**Re: City of Winnipeg - Southwest Rapid Transit Corridor – Stage 2 Project
Environment Act Licence No. 3121 E. FILE NO. : 5709.00**

FIGURE EIA-003
PARKER LANDS - DRAINAGE PLAN
DRAWING 1 OF 2

City of Winnipeg Southwest Rapid Transit Corridor (Stage 2) Project
Environment Act Licence No. 3121 E.
CLIENT FILE NO. : 5709.00

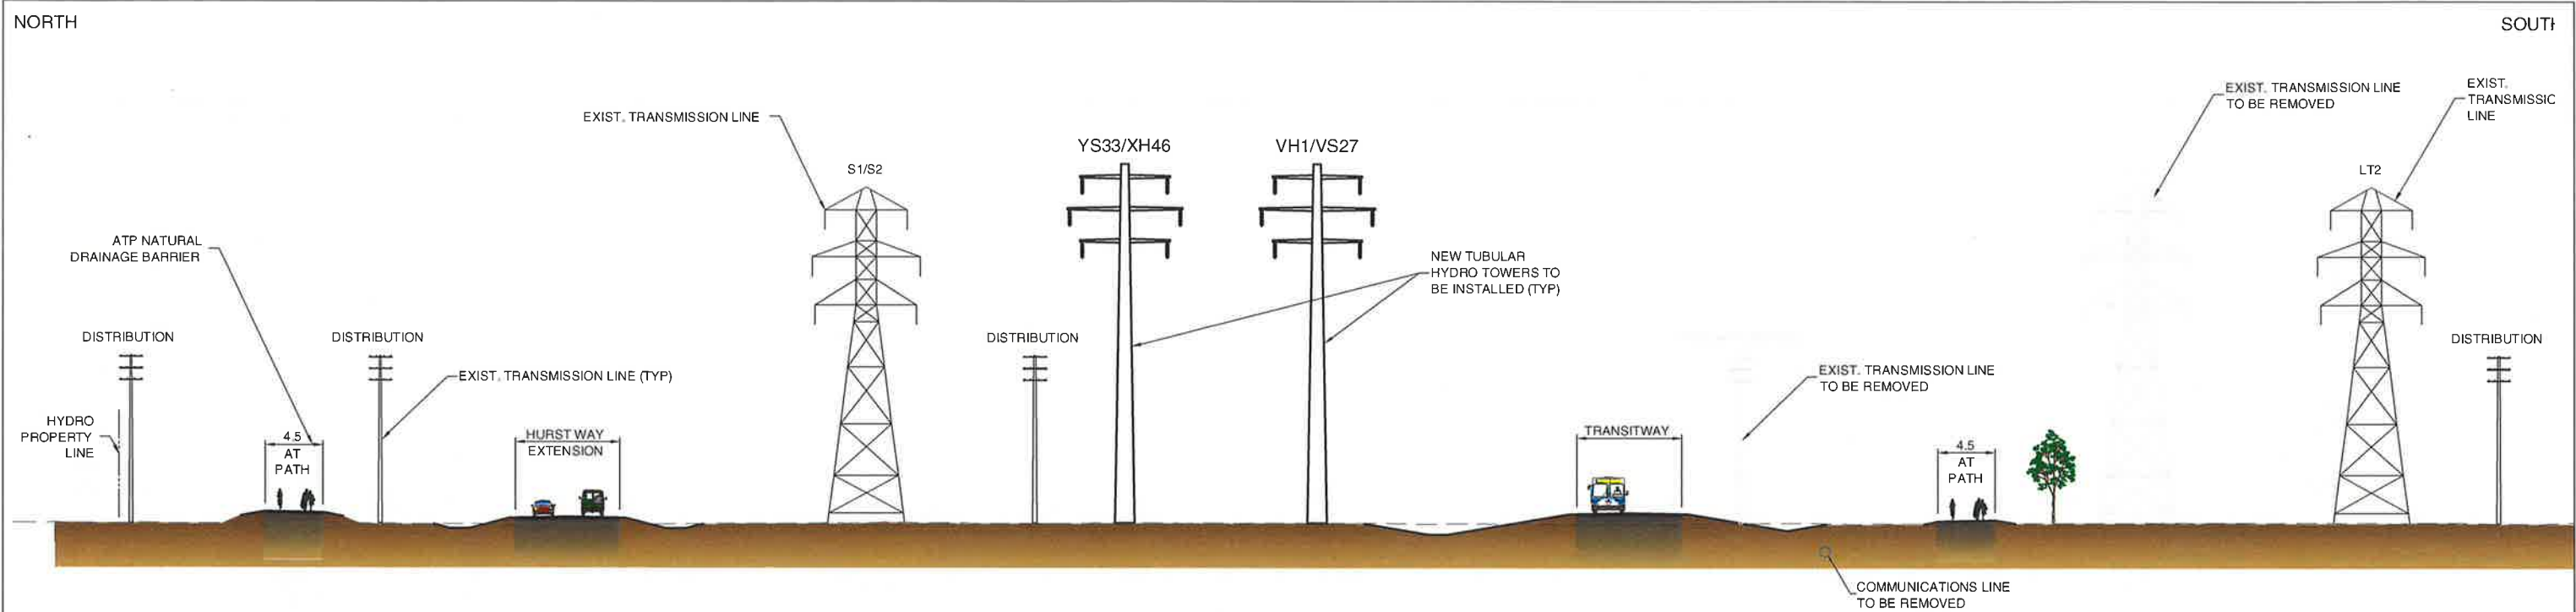
The City is requesting revision to Environmental Approvals, Licence No. 3121 E, Clause 13 which states: “The Licencee shall implement the drainage plan outlined in the report submitted to the Director of the Environmental Approvals Branch on June 18, 2015 titled “Southwest Transitway - Stage 2, Additional Information on Drainage and Natural Areas in the Parker Lands””. The section of berm running east from the AT path to the north of the station and then running towards the CN property on the west side of the pond has not been built. This final section of berm, as described in the attached, is not required due to sufficient elevation to prevent drainage. We are requesting your concurrence that the highlighted berm is not required as originally presented in the June 18, 2015 report.

Environmental Approvals, Licence No. 3121 E, Clause 13 states: "The Licencee shall implement the drainage plan outlined in the report submitted to the Director of the Environmental Approvals Branch on June 18, 2015 titled "Southwest Transitway - Stage 2, Additional Information on Drainage and Natural Areas in the Parker Lands"". To date, the contractor (PCL) has built the Active Transportation (AT) path from the Humane Society (far left on Figure EIA-003, attached) parallel to Hurst Way to the north and then parallel to Georgina Street to the east and tying it into the Beaumont Station (which is labelled Parker Station on Figure EIA-003 as this drawing was produced prior to the name change). The section of berm running east from the AT path to north of the station and then running towards CN property on the west side of the pond has not been built (highlighted on Figure EIA-003).

Dillon has assessed the construction progress along with the recent information provided by the contractor. Based on this review, Dillon is in agreement that the final section of berm (highlighted on Figure EIA-003) is not required due to sufficient elevation to prevent drainage as well as the changes to the surrounding lands.

This information has been discussed with Ms. Elise Dagdick of Manitoba Sustainable Development in December with follow-up in January. Ms. Dagdick understands our position that there is no further benefit in constructing the final section of berm to prevent drainage out of the GEM lands. She has indicated that her department is prepared to receive and review this request to amend Environmental Approvals, Licence No. 3121 E, Clause 13 in accordance with Figure EIA-003, deleting the berm highlighted on the drawing.
